**To:** Michael Herring, City Administrator  
*moZ*  
**From:** Mike Geisel, Director of Planning & Zoning  
**Date:** 10/31/2008  
**Re:** Phase two construction, CVAC

**Total change order      \$350,000**

***Accordingly, I recommend that City Council approve a second change order with Frederich Construction in an amount not to exceed \$350,000, increasing the total authorized contract amount to \$5,767,581 for the original contract work associated with Construction of the Parks Maintenance facility, as well as the changes described above for the proposed parking lot and infrastructure extensions to serve the "F" athletic fields. This work would be funded entirely from Proposition P funds, which would of course, be replenished when financing for Phase Two work is ultimately received.***

CITY OF CHESTERFIELD  
 CHESTERFIELD VALLEY  
 ATHLETIC COMPLEX  
 EXPANSION PACKAGE 7  
 F PARKING LOT SITE PLAN

**F PARKING LOT SITE PLAN**  
 SCALE: 1"=60'

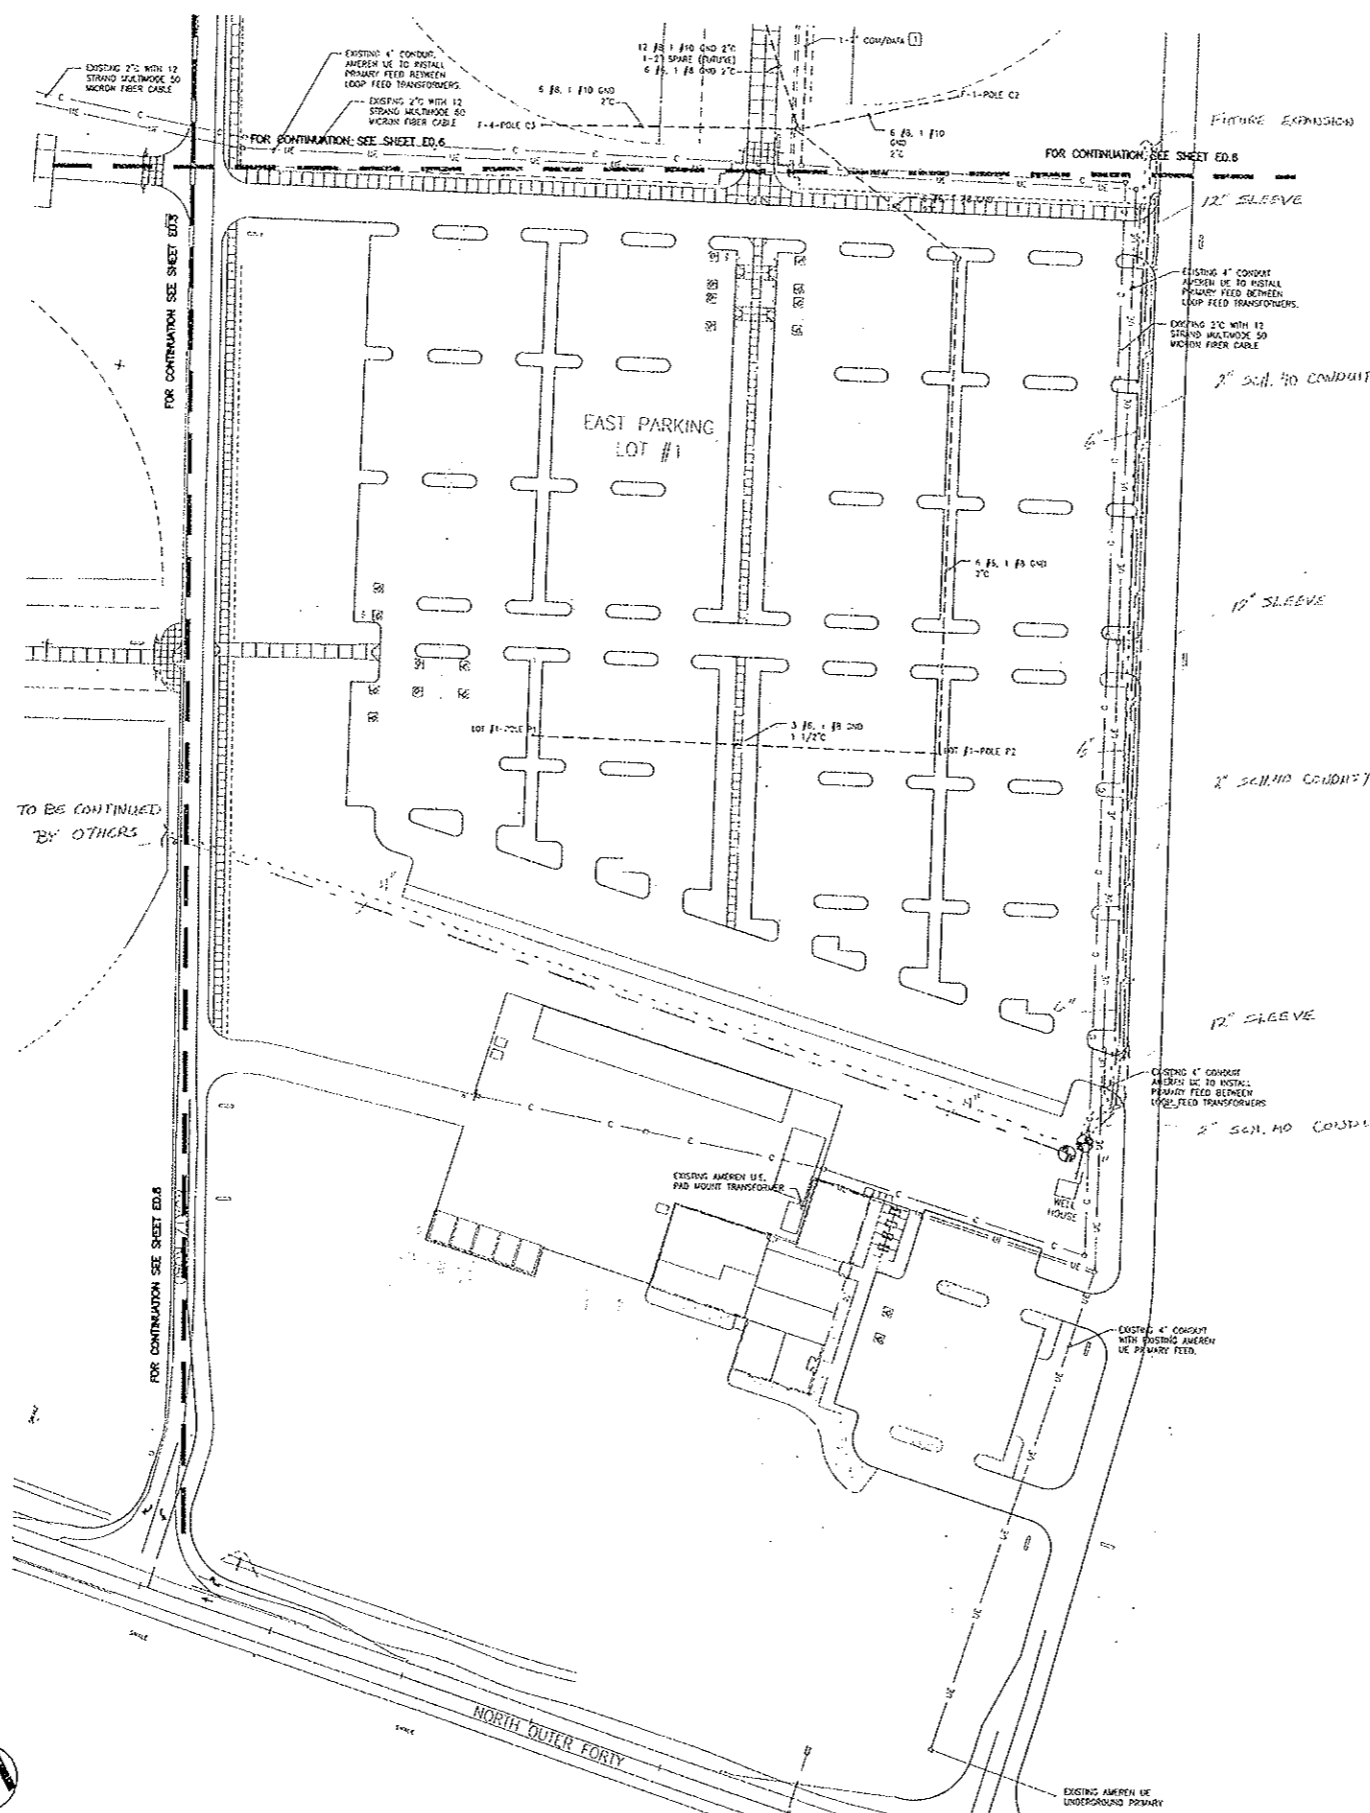
### RFP # 60 Water Fire Sanitary north of CVAC-5

8" PVC	2500 lf	18.17	45,425.00
6" PVC	300 lf	9.50	2,850.00
4" PVC	300 lf	7.17	2,151.00
8" PVC Water Line Tap	1	3,000	3,000.00
4" Water Valve	3	519.00	1,557.00
6" Water Valve	4	543.00	2,172.00
8" Water Valve	6	950.00	5,700.00
8" Water Line Plug	1	400.00	400.00
Fire Hydrant	4	744.00	2,976.00
18 X 36 Trenching	3100 lf	8.90	27,590.00
¾" crushed stone	400 ton	22.00	8,800.00
24 x 24 Precast HH	4	1,500.00	6,000.00
Cleanout	8	400.00	3,200.00
Clean Out w/ Sampling Tee	4	1,500.00	6,000.00
Grease Trap	1	4,000.00	4,000.00
Sanitary Manholes	3	4,200.00	12,600.00

Total Includes OH & P \$ 161,305.00
